Site Investigation Work Plan Addendum

Shell-branded service station 8930 Bancroft Avenue Oakland, California Incident # 98995742 Cambria Project # 243-1408

1 - Site Plan

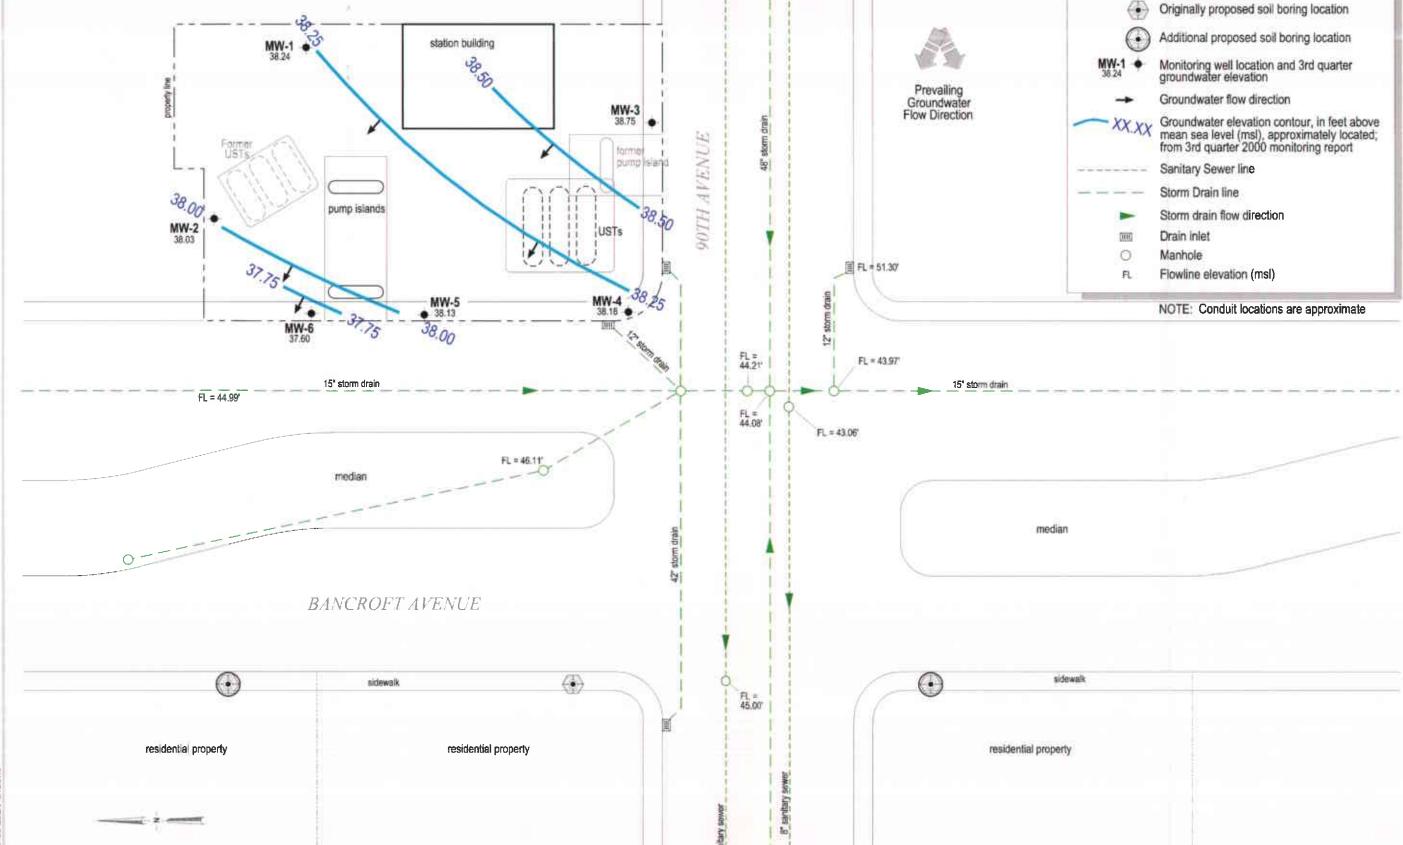
Figure 1 is a revised site plan showing the original and additionally proposed boring locations. All three borings will be installed downgradient from the site in the public right of way adjacent to nearby residential properties. The additional borings will be installed in the same manner as the originally proposed boring and all other aspects of this investigation will be performed in accordance with Cambria's November 2000 Site Investigation Work Plan.
